Huntington County Community School Corporation Riverview Middle School Student Pick Up Lane Project

Project # 2025.0011

ADDENDUM NO. A-1

Huntington County Community School Corporation Riverview Middle School Student Pick Up Lane Project Pre-Bid Meeting Minutes

SHEET
C1.0

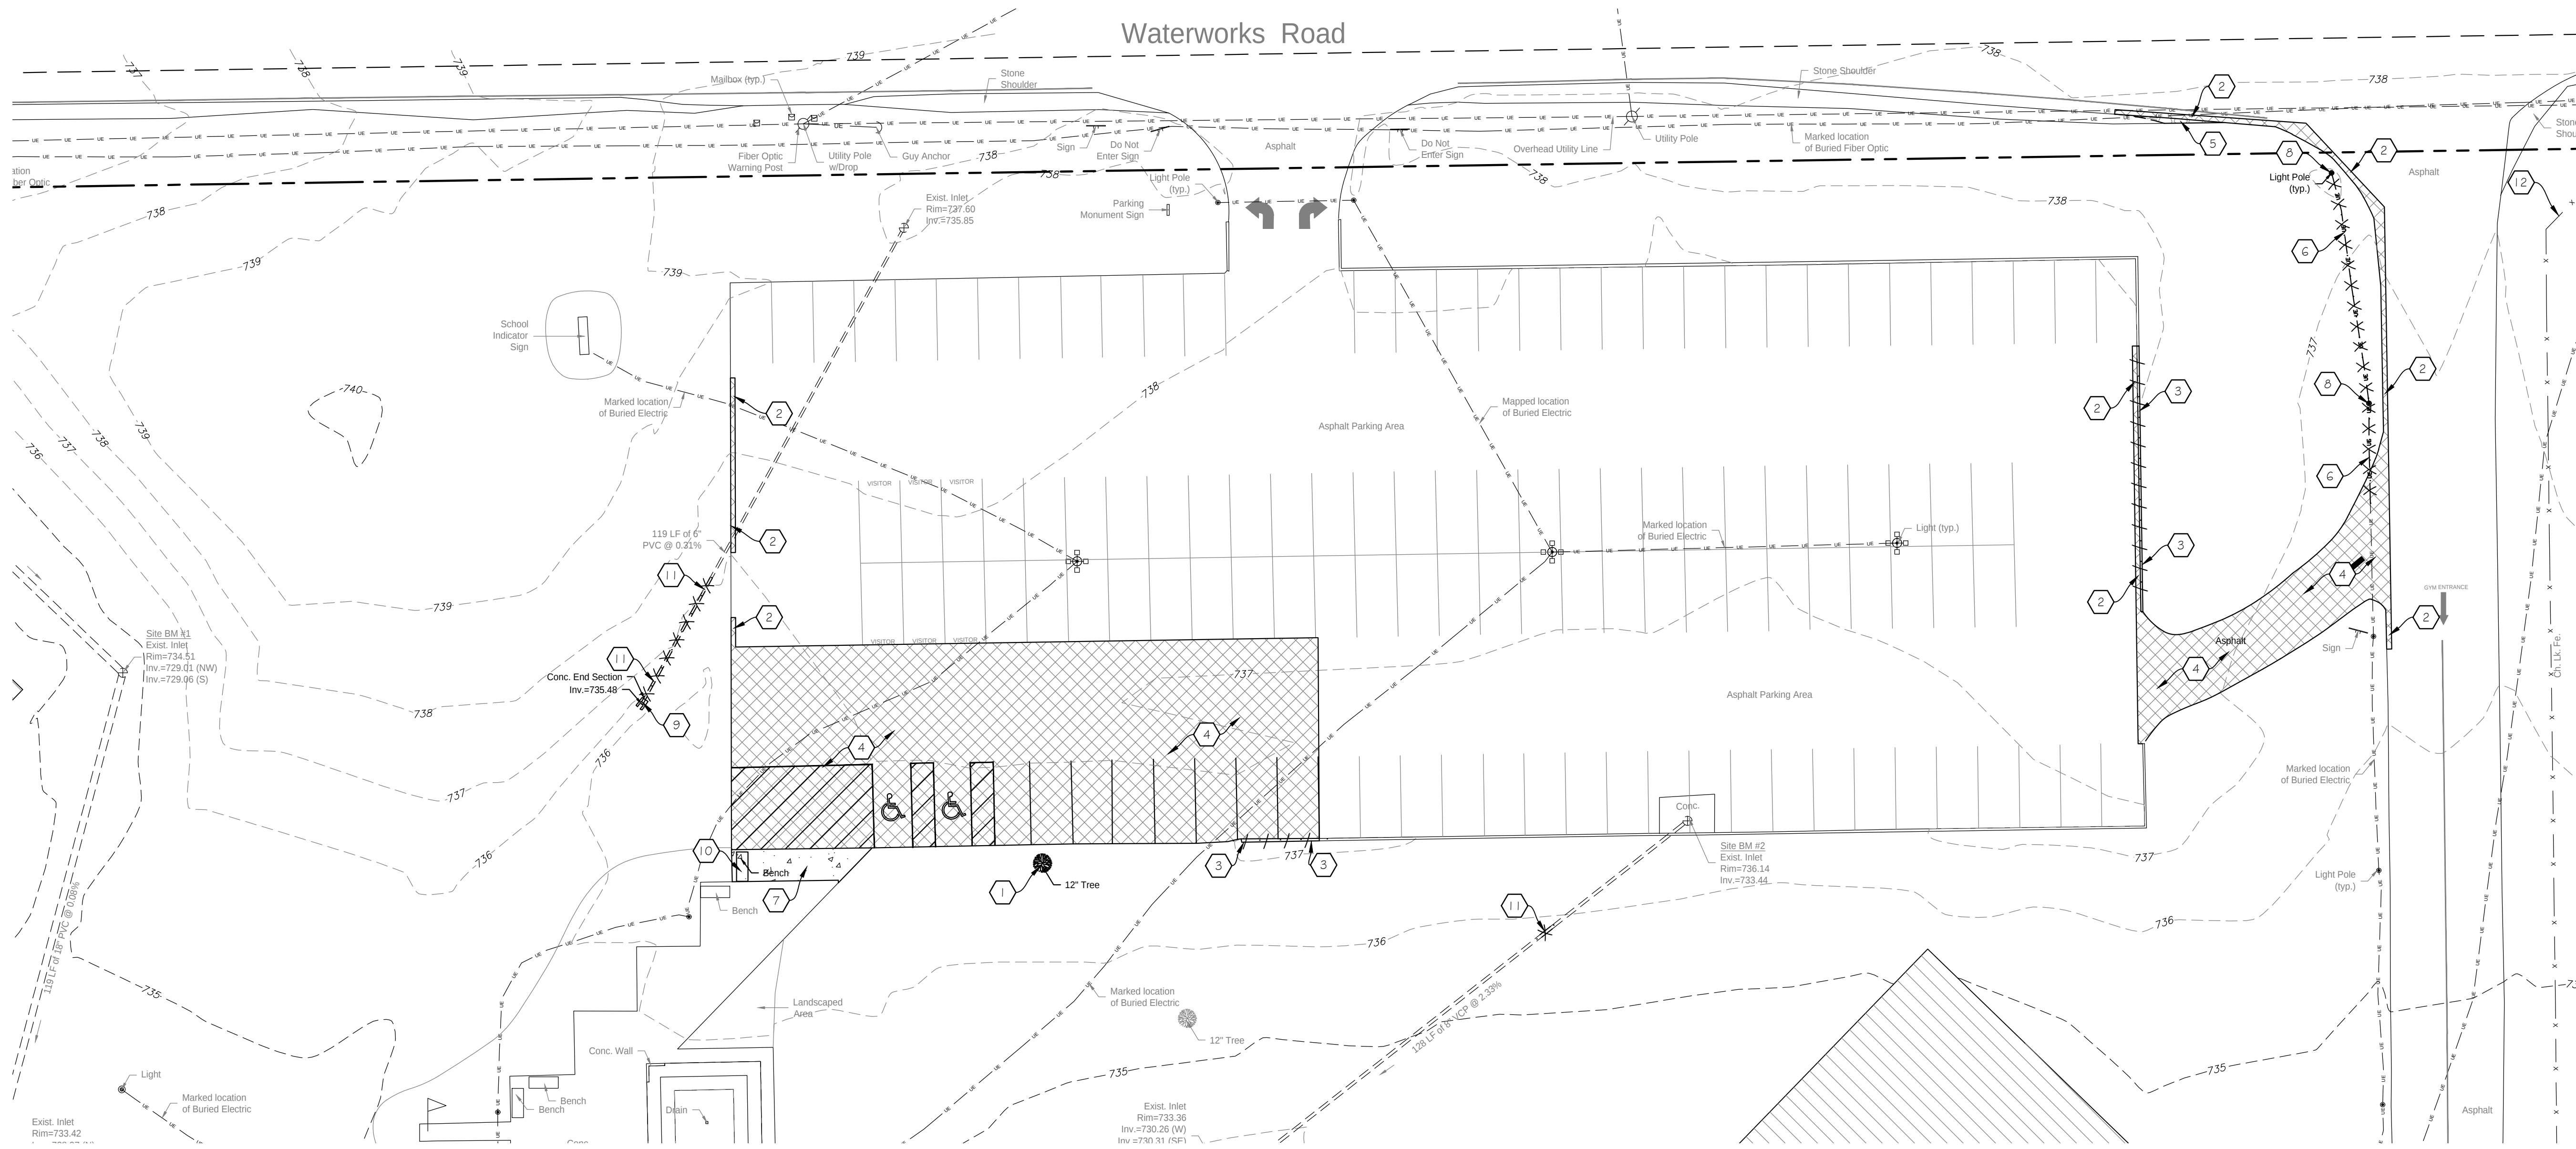
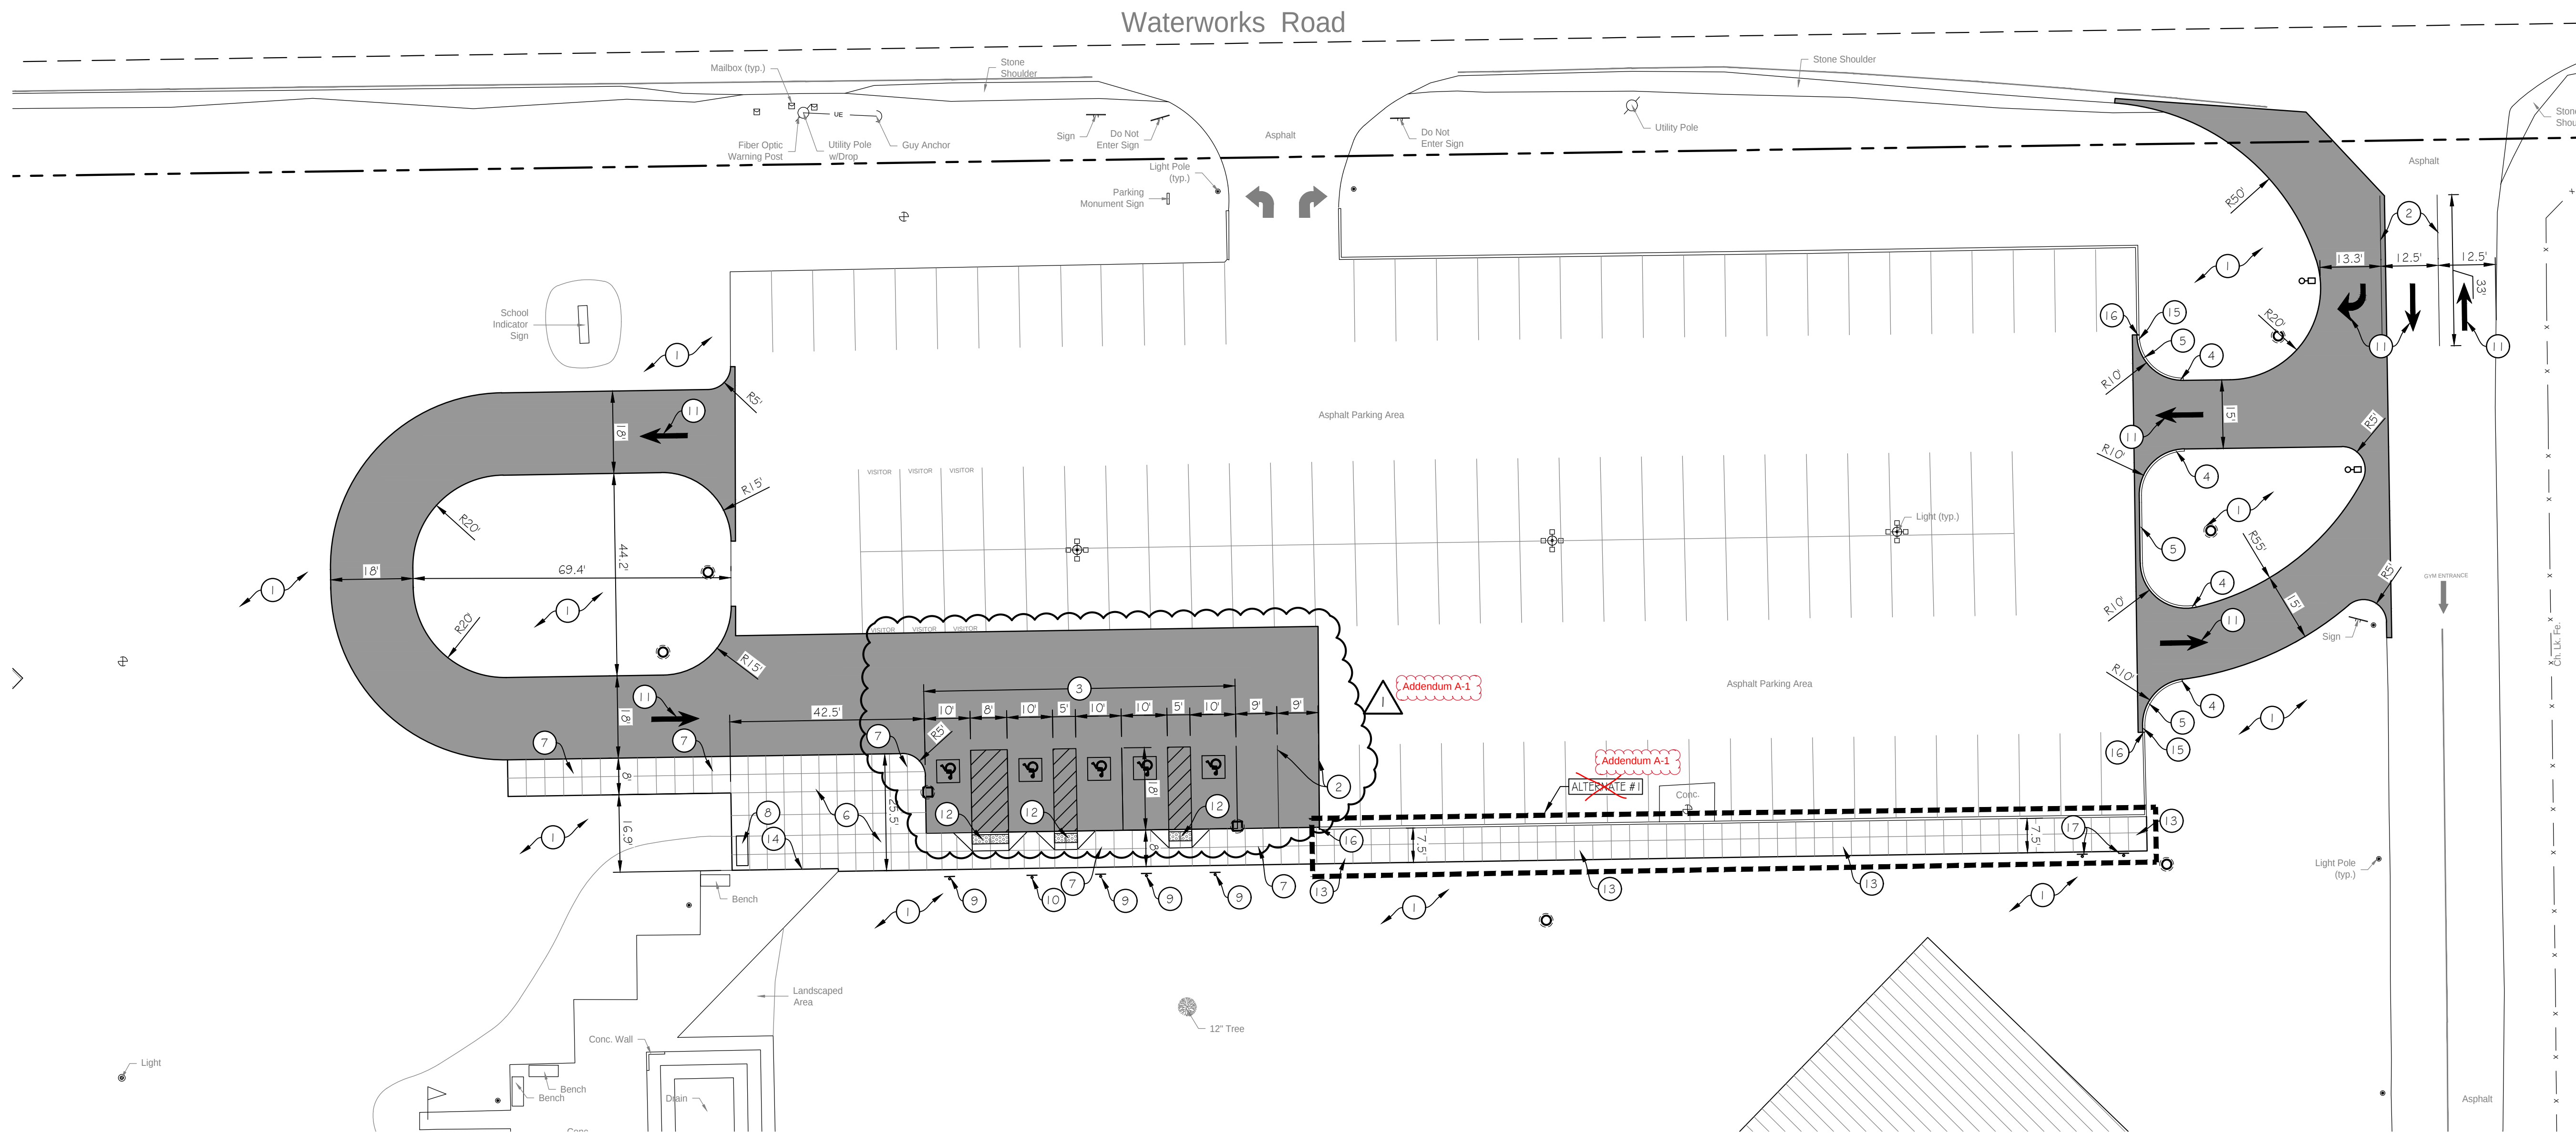
- Sheets C1.0, C2.0 New Parking space layout - REVISED

- Additional Accessible Parking Space and curb cut at sidewalk added.
- Parking layout revised.

- Sheet C1.0 Sidewalk indicated as Alternate #1 – Note removed.
